HAN DIEC ADDITION

RE: SUB 2001-104 -- One-Step Final Plat of Han Diec Addition

At the regular meeting of the Subdivision Committee of the Metropolitan Area Planning Commission on Thursday, October 18, the above captioned plat was considered. The action of the Committee was to approve the final plat, subject to the following:

CASE NUMBER: SUB 2001-104 -- HAN DIEC ADDITION

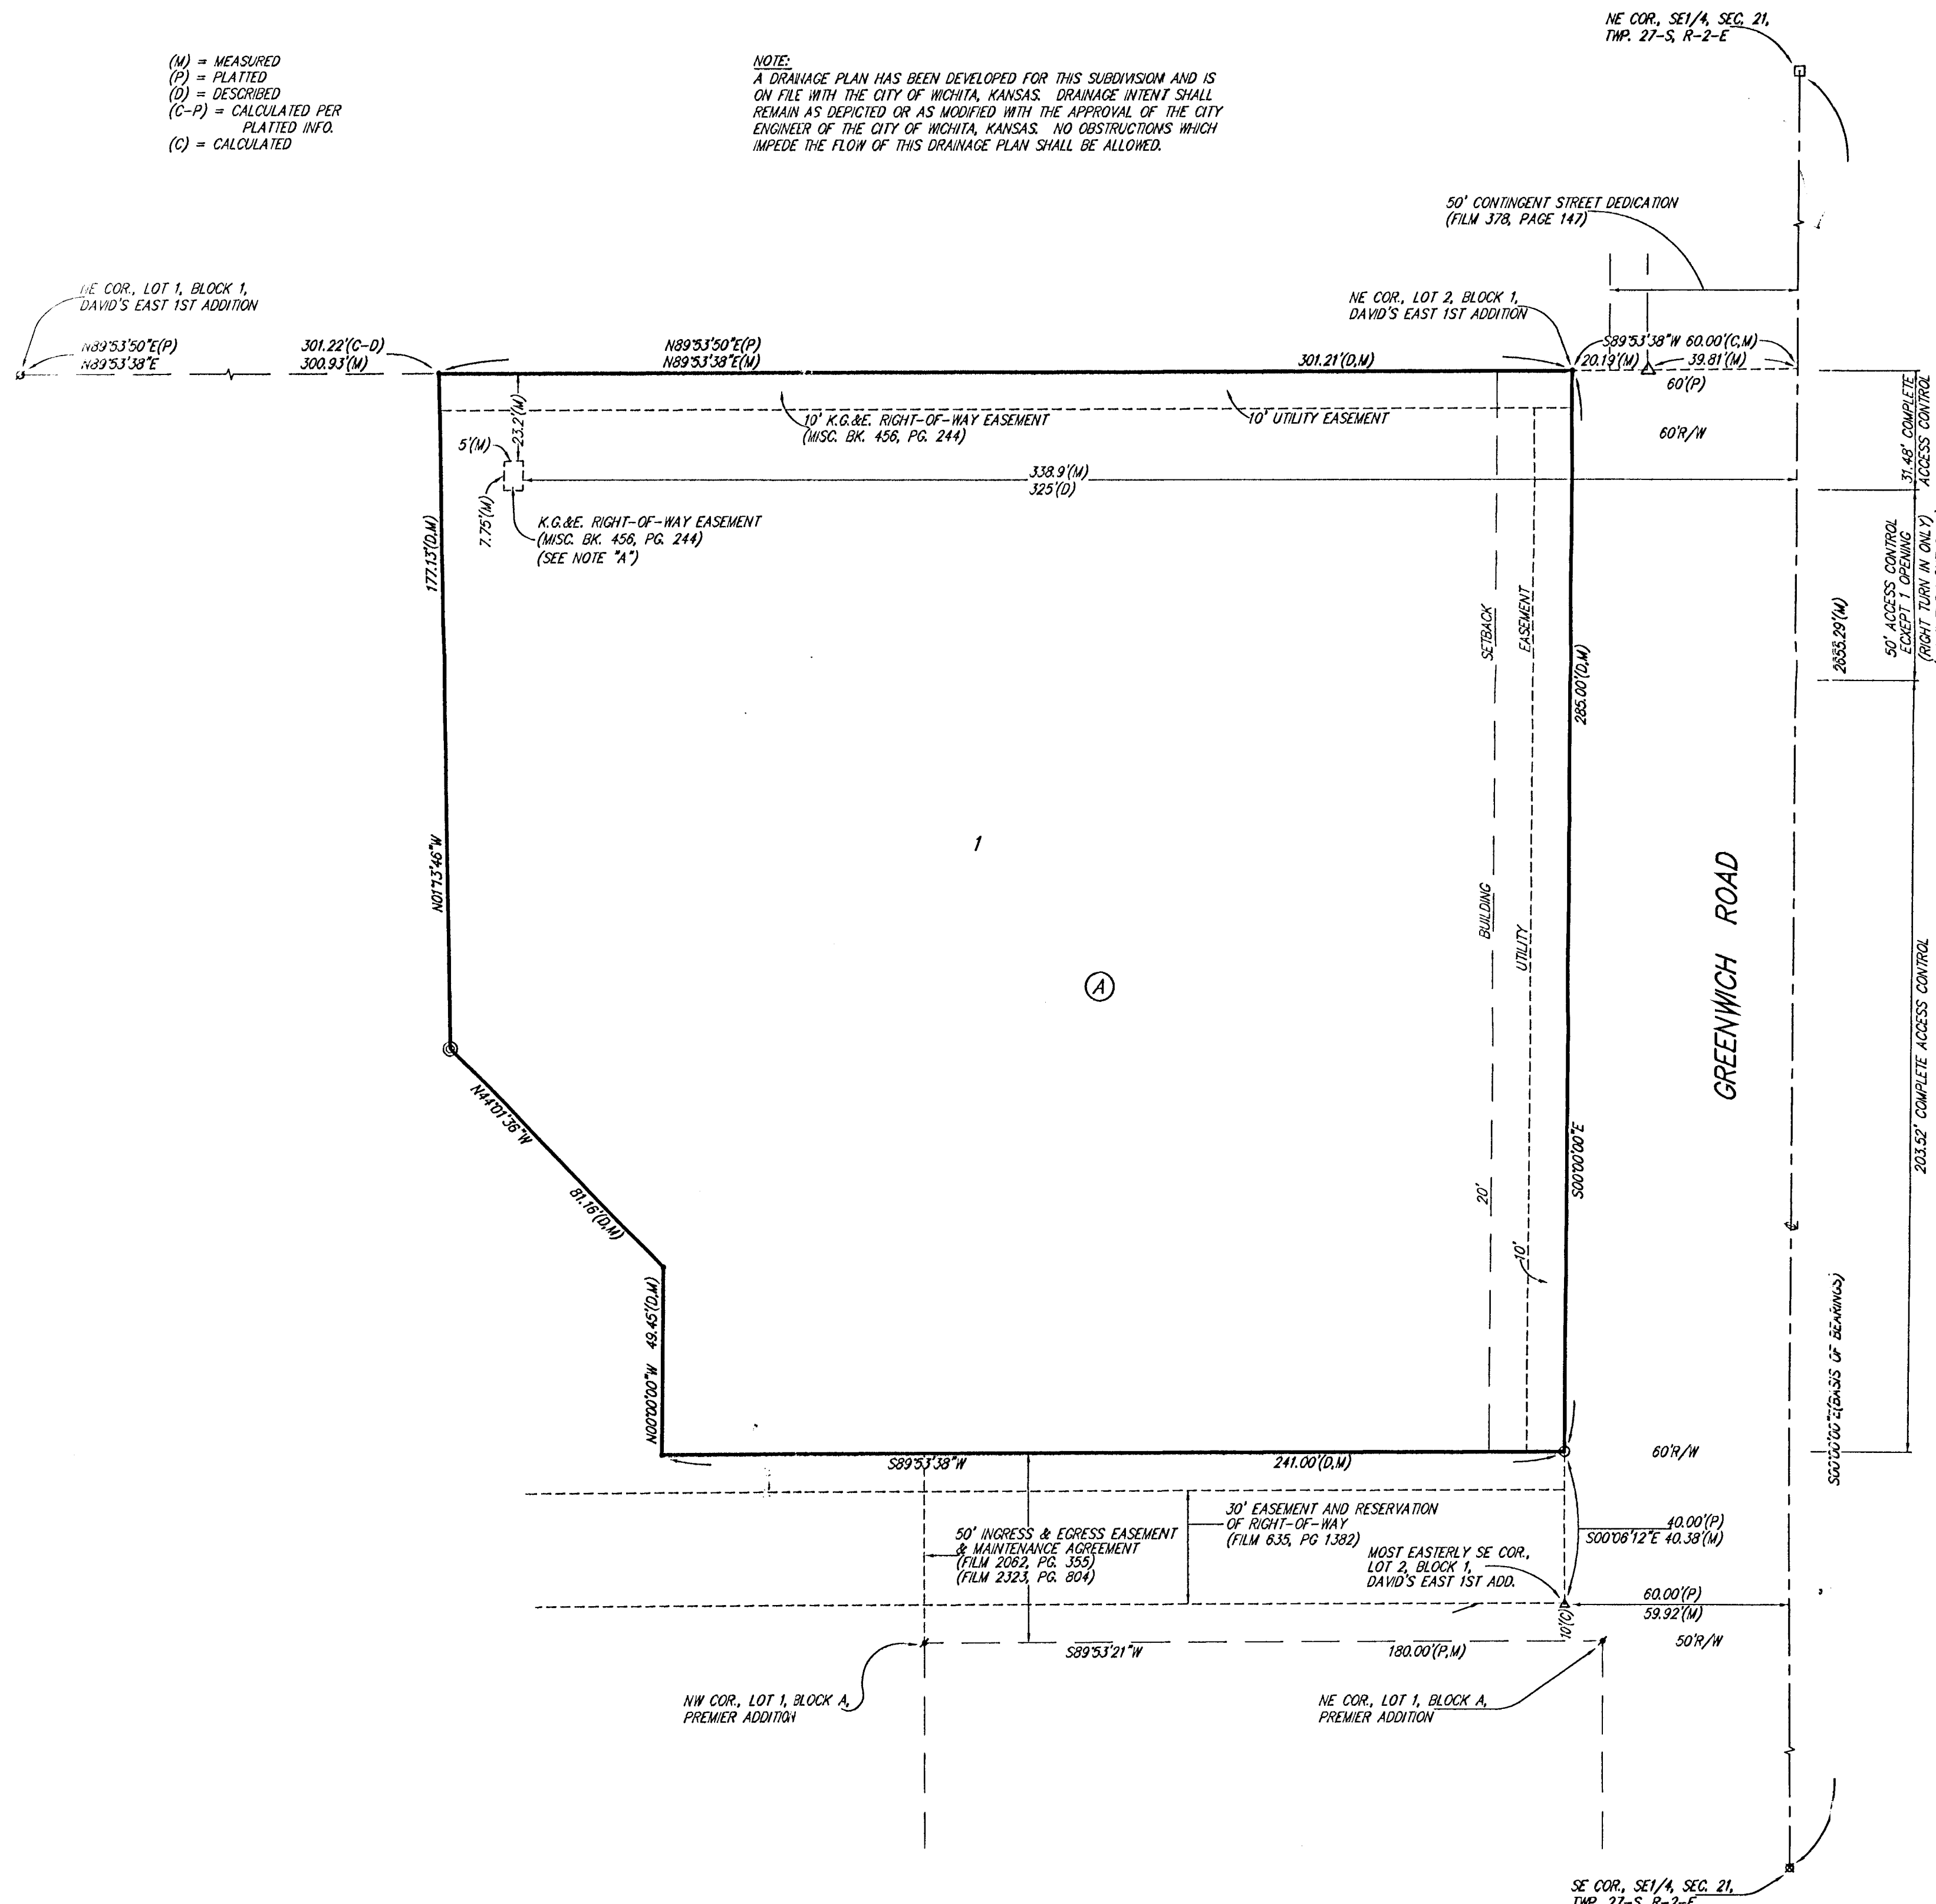
- C. City Engineering needs to comment on the status of the applicant's drainage plan. The drainage plan is approved.
- D. The plat proposes one access opening along Greenwich. Traffic Engineering needs to comment on the access controls. Traffic Engineering and MAPD have recommended access control except for one joint opening with the abutting lot to the south. The Subdivision Committee has permitted one access opening to be located 150 feet from the opening for the abutting property to the north.

- F. On the final plat, the MAPC signature block needs to reference "J.D. Michaelis, Chair".
- G. The Applicant is advised that if platted, the building setback may be reduced to 20 feet.

- I. The platting text shall include language that a drainage plan has been developed for the plat and that all drainage easements, rights-of-way, or reserves shall remain at established grades or as modified with the approval of the applicable City or County Engineer, and unobstructed to allow for the conveyance of stormwater.

- Q. The representatives from the utility companies should be prepared to comment on the need for any additional utility easements to be platted on this property. **Southwestern Bell has requested additional easements.**
